RIVER DISTRICT DESIGN COMMISSION REGULAR MEETING AGENDA

July 13, 2023

DATE: July 13, 2023
TO: River District Design Commission
FROM: Renee Burton, Division Director of Planning
RE: PZ23-00212 is a request filed by ARRG Properties, LLC to deconstruct 601 Lynn Street and build a new 125 unit apartment.

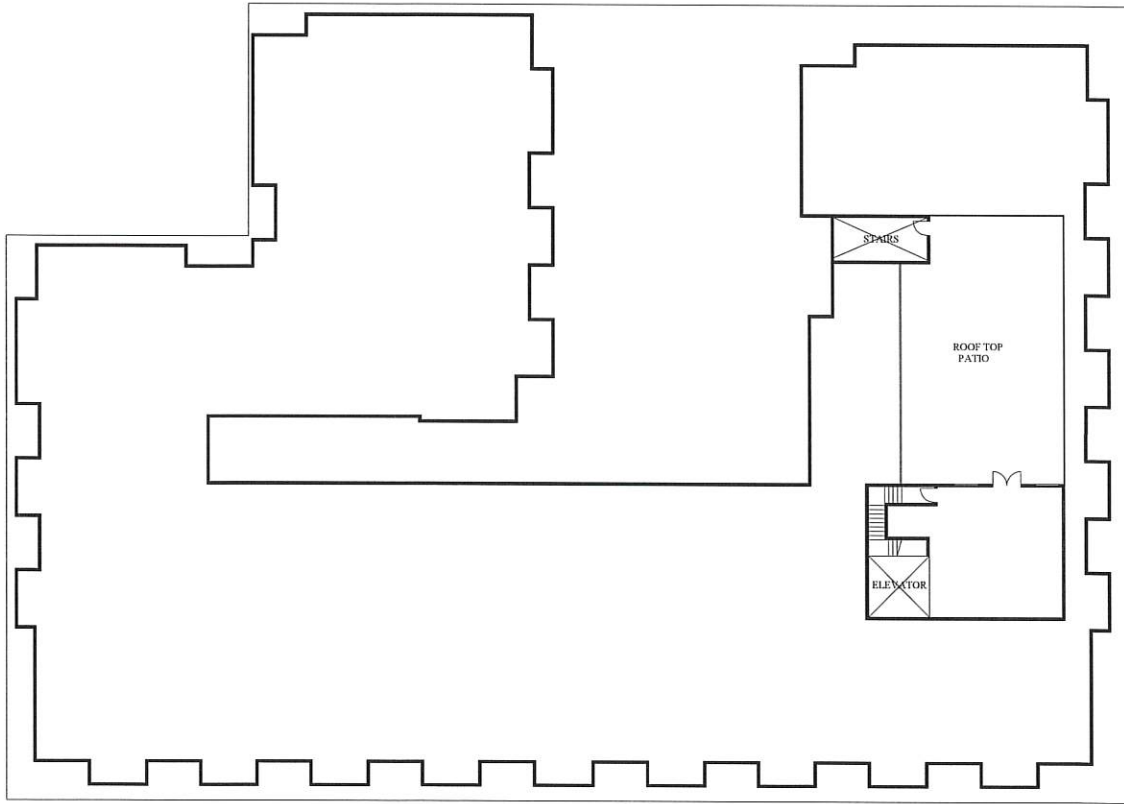
According to the design guidelines, the proposed materials and scale are appropriate for the area. However, the exterior patios along Deboe and Lynn Street are inconsistent with other structures in the area. The warehouses generally possess flat facades and windows with a vertical emphasis. The elevations propose recessed patios and what appear to be square windows.

The Planning Staff recommends that the River District Design Commission evaluate the proposed construction and use prior to making a decision on the demolition of the existing structure at 601 Lynn Street. The decision of demolition should not be taken lightly and should only be considered if necessary for safety and/or the infill design for redevelopment is appropriate for the River District.
